USTA AT LAKE NONA

SUMMARY

MASTER PLAN ANALYSIS

PROPOSED SITE PLAN

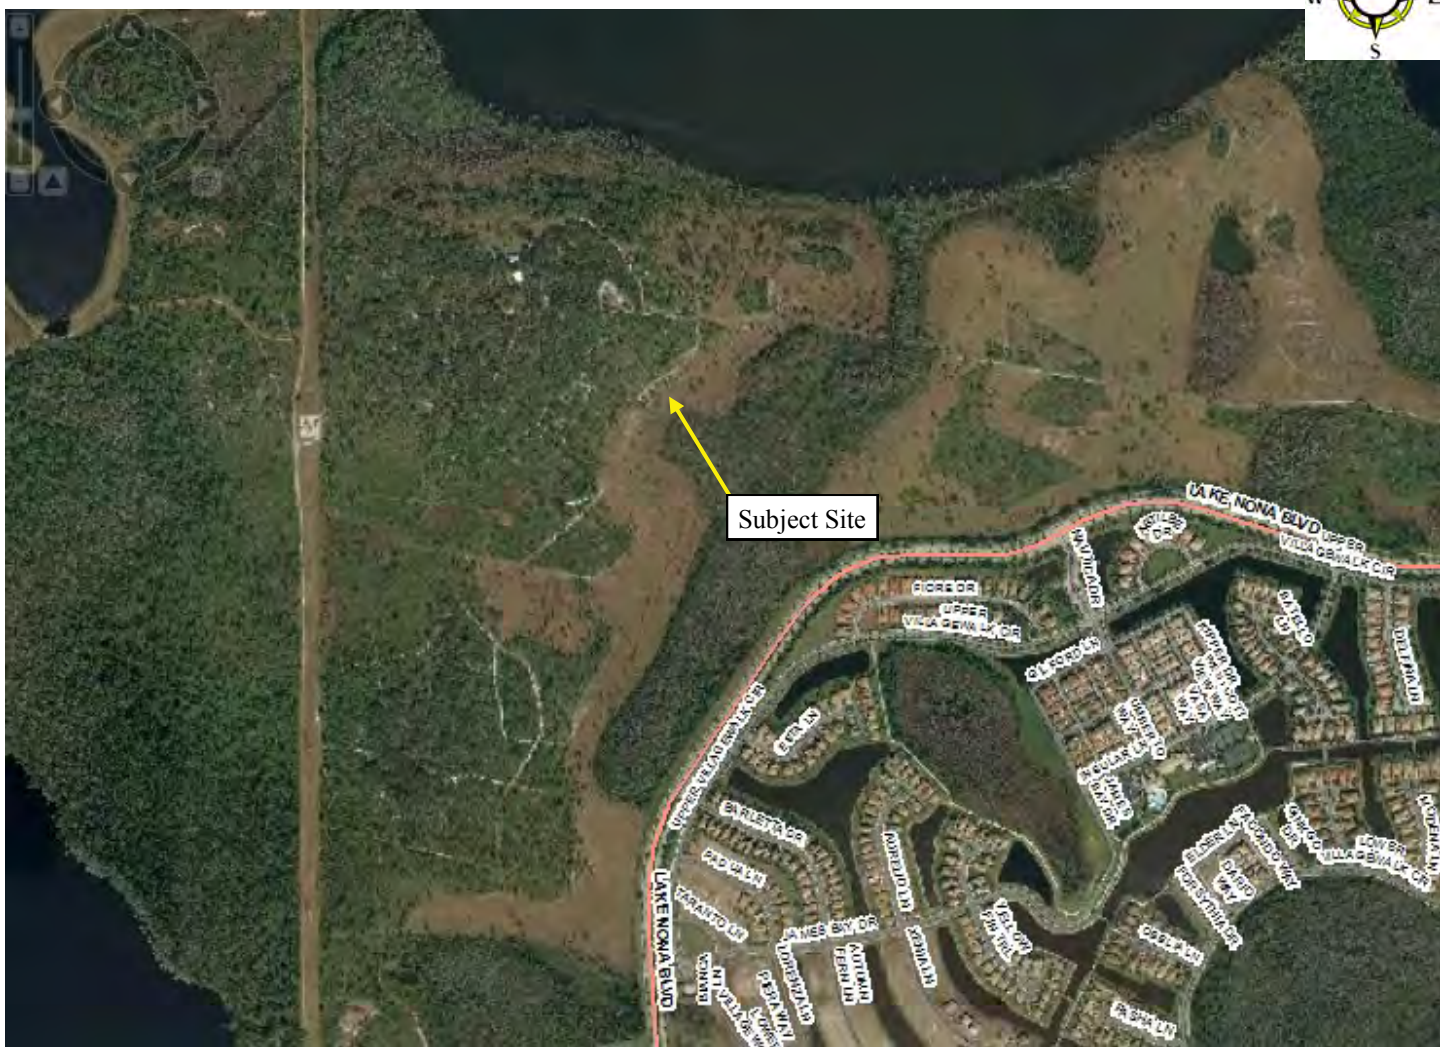
On-site parking as shown is appropriate for Phase 1 of this development. Applicant shall provide a narrative or depiction of how many spaces will be added and their approximate location to meet the demands created for Phase 2. This information shall be provided one week prior to appearance before SETDRC to allow for staff review.

ROADWAY CROSS-SECTIONS—USTA BOULEVARD

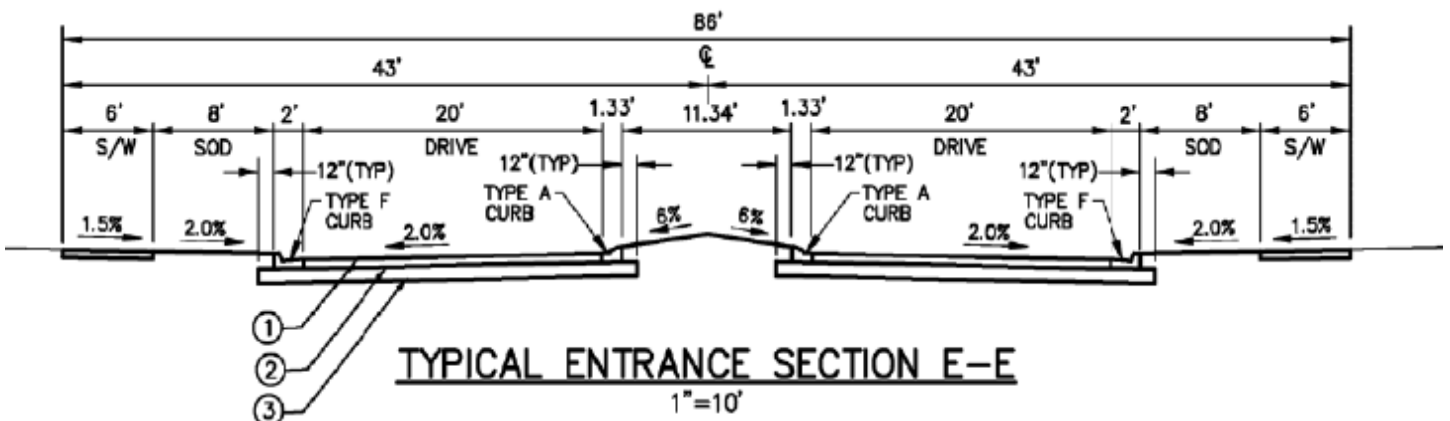
8. *USTA BOULEVARD CROSS SECTION*

The full build out four lane cross section shall be revised as per the condition of the Transportation Planning staff.
